SERVICE INFORMATION NO. SI36-038

Replacement of Fuel Pump

ALERT SERVICE BULLETIN

SB-912-053

(see Fig.1)

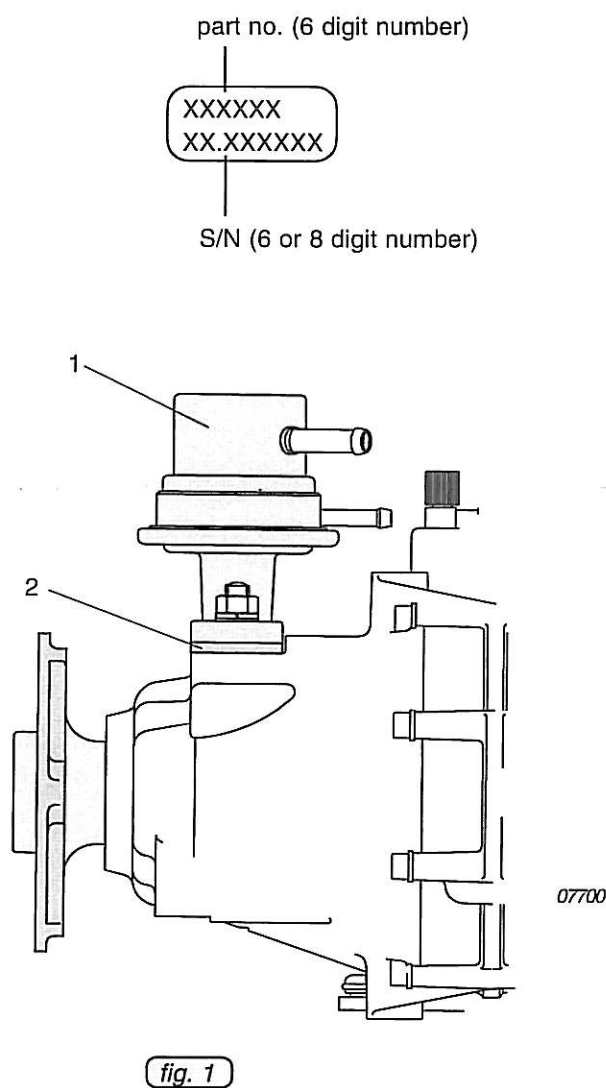
1. Remove fuel pump (1).

2. Gasket (2) replaced by new part.

■ **CAUTION:** Install new gasket supplied with new fuel pump. The thickness is different.

3. Install fuel pump. Tightening torque 15 Nm (133 in.lb).

4. Install fuel line.
